## ADDENDUM NO. 1

Reference: Chillers Replacement – Dee Event Center  
Weber State University – Ogden, Utah  
DFCM Project No. 10225810

**ADDENDUM NO. 1**

**WSU Dee Events Center Chiller Replacement**

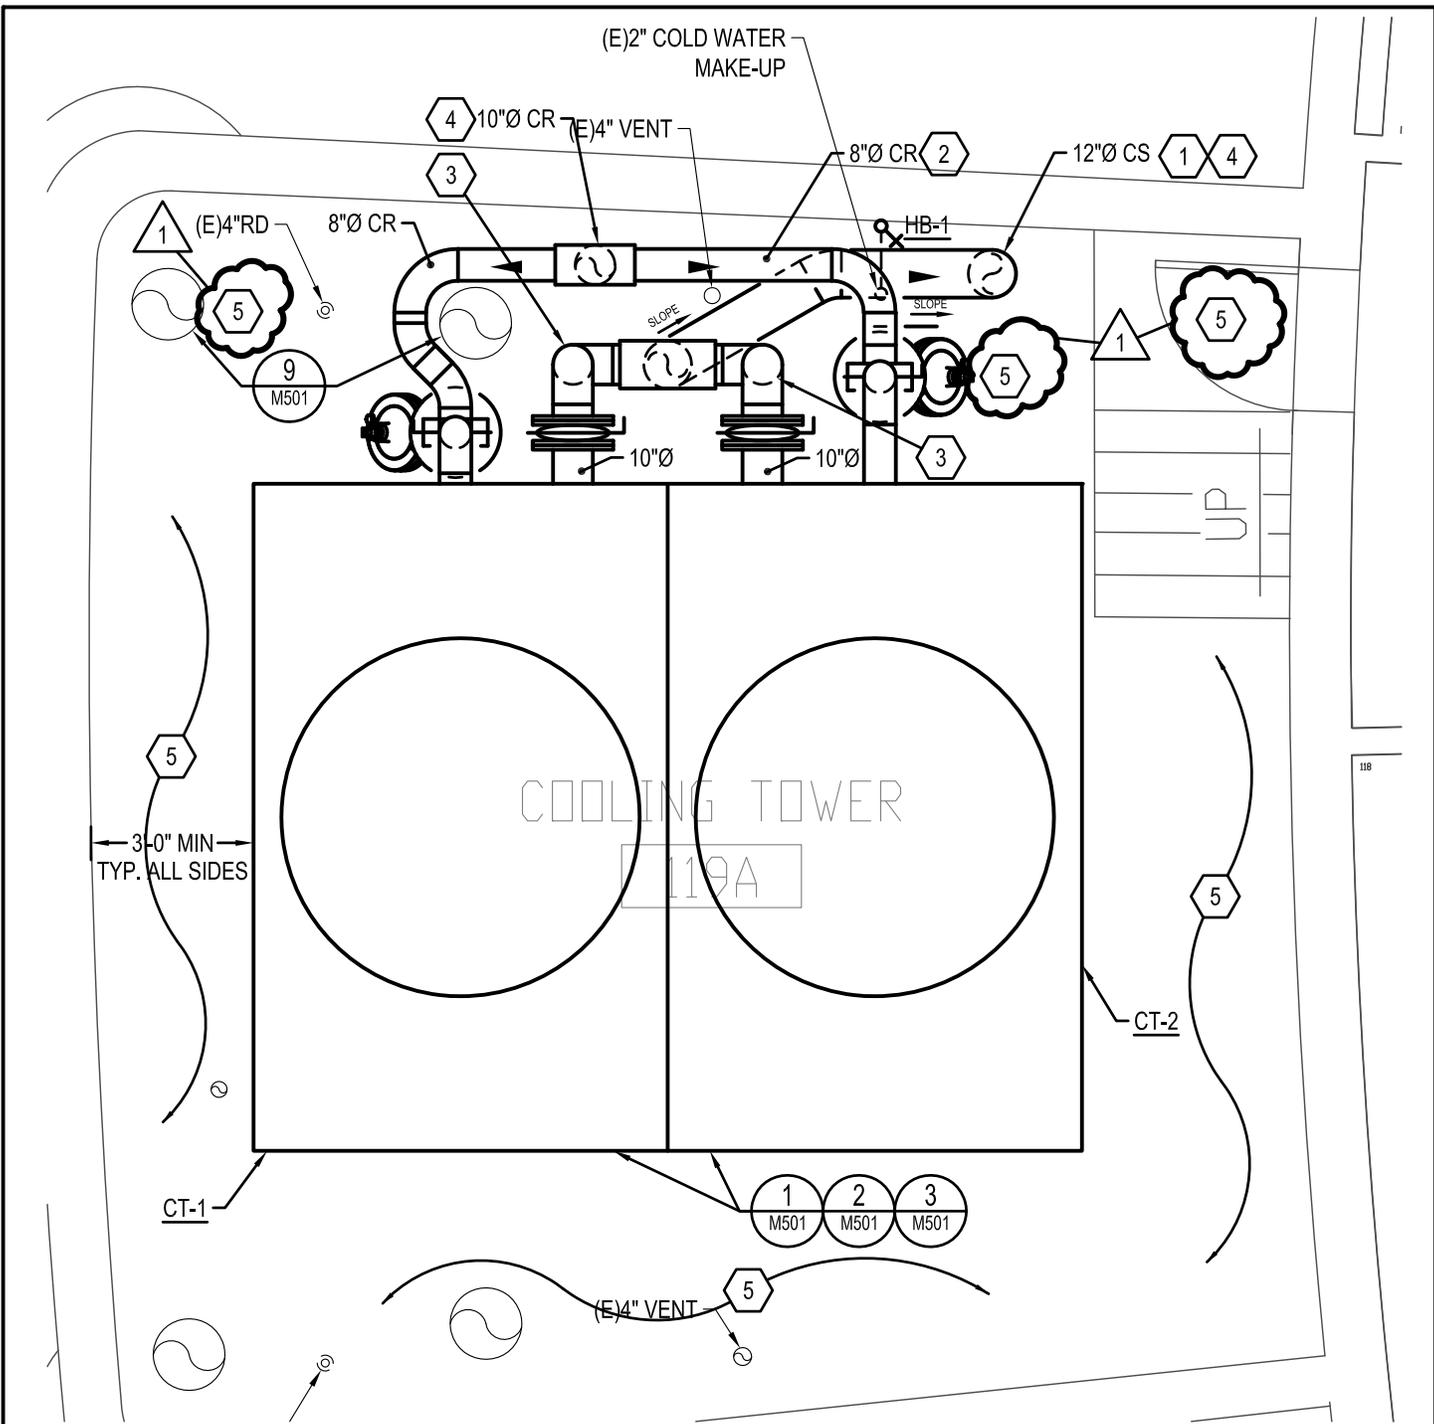
<b>Item No.</b>	<b>Add, Delete or Clarify</b>	<b>Specification Section or Drawing No.</b>	<b>Reference / Description:</b>
1.1	Clarify	C001	Correct the sheet index to show sheets M401 and M402 per attached sheet AD1.01.
1.2	Add	M101	Replace the existing wood landing and stairs in the cooling tower enclosure per attached sheet AD1.02.

5. REMOVE EXISTING WOOD DECK, LANDING, HAND RAIL, AND STAIRS IN COOLING TOWER AREAWAY, AND REPLACE WITH NEW DECK, LANDING, STAIRS, AND HAND RAIL USING COMPOSITE DECK MATERIAL ON ALL HORIZONTAL WALKING SURFACES, PRESSURE TREATED LUMBER FOR THE SUPPORT STRUCTURE BENEATH THE COMPOSITE DECK MATERIAL, AND STAINLESS STEEL HARDWARE AND FASTENERS. NEW DECK SHALL BE AT SAME ELEVATION AS EXISTING DECK, AND SHALL COVER THE SAME AREA.
